Network Improvements on the UK Dover (DVR) Interface

Gateway Documentation:
Stage 1 Define
ACP-2025-006

Figure 4 - Traffic via KONAN or VABIK. Primary area of scope (purple box), FIR / UIR boundary (black line), COPs (blue circles). Source: CMFU actual, August 2024, overlaid onto SkyVector.com World Hi map.

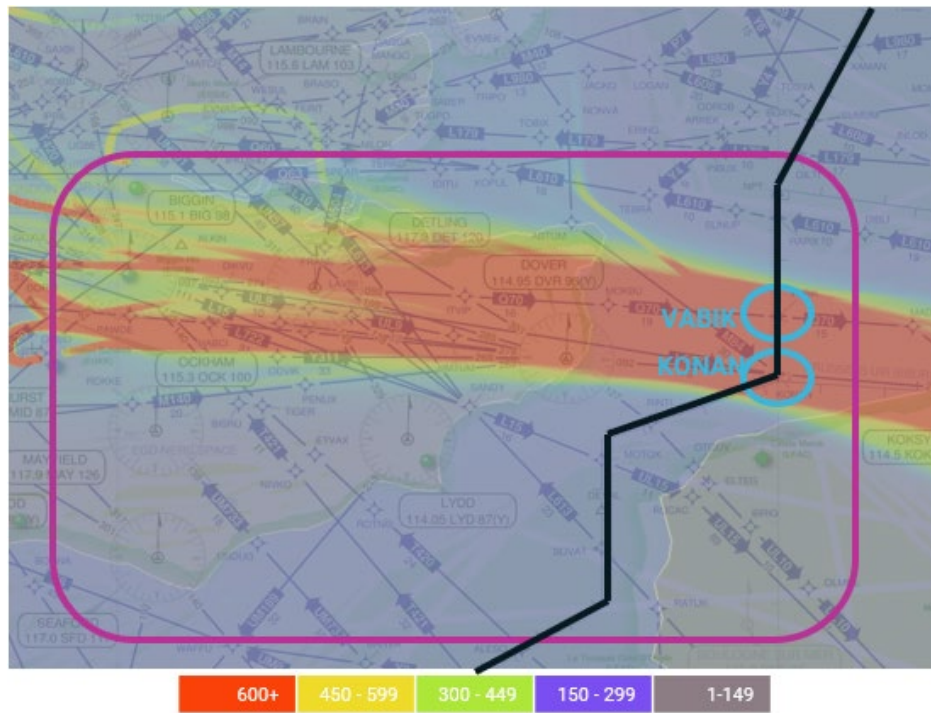
Feedback	Stakeholder(s)	NERL Response
Situation is true, but almost in every case radar-vectoring provided by ATC and seldom in own navigation.	Austrian Airlines	NERL agrees that currently the majority of traffic is given ATC radar-vectoring, rather than remaining on their flight planned route. NERL believes this is reflected in Figure 4 and hopes to alleviate this issue via this change. No change to current day scenario.
